SUBMITTAL RECORD

Norcross, GA — Lidl #1517 | Job 15170000GR
4990 Jimmy Carter Blvd, Norcross, GA 30093

PSI Log #	SUB-009 (Rev 0)	Procore #	1-2.0 — Mast Arm Pole Shop Drawings #1, #2, #3
Fieldwire #	PSI-0006 — Shop Drawings for the Mast Arm Poles	Type	Shop Drawing
Spec Section	None assigned — Procore "1 - Default Section"	Status	Pending — no response. OVERDUE (Fieldwire response due 09/25/2026)
Subcontractor	R.J. Haynie & Associates (ship-to); sold to DOT Lighting, LLC; agent Traffic & Lighting Corp; manufacturer Valmont Industries (Valley, NE)	Submitted By	Tucker Teague (Place Services Inc.) — PSI stamp No Exception Taken 9/18/2026 (all 3 sheets)
Scope / Location	Off-site traffic signal structures: Gwinnett County TS-082, Jimmy Carter Blvd @ Shelby Dr	Ball in Court	Christopher Manes (CHA Consulting, Inc.)
Issue Date	Sep 18, 2026	Final Due Date	None set in Procore
Procore Received	Sep 25, 2026	Description	Place Services Inc. - No Exceptions Taken
Distribution	Christopher Manes, JaWanna English-Neal, Jeff Belyea, Todd Seldomridge (CHA Consulting); Jens Byer (Lidl US); Bobby McTeague, Luis Marcelino, Tucker Teague (Place Services Inc.)

Submittal #1-2.0 - Mast Arm Pole Shop Drawings

ORDER NUMBER: 672263-P1	
PAGE NUMBER: 2	OF 2
DRAWING NUMBER	REV
GA672263P1

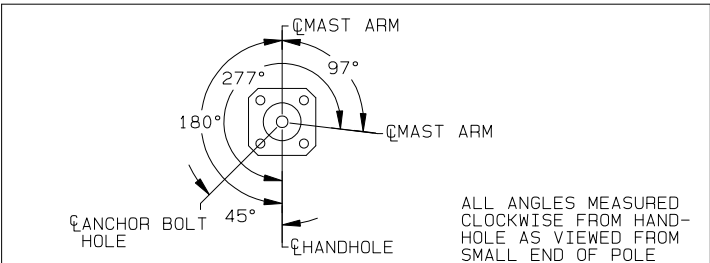
Note: "Pole Foundations — 3'-0" Dia x 14'-6" Deep - (8) #10 Rebar" (Poles B & C) on Dwg #2 is an unsigned text annotation added to the PDF, not part of Valmont's sealed drawing. Verify foundation design against the signal plans / county standard before drilling.
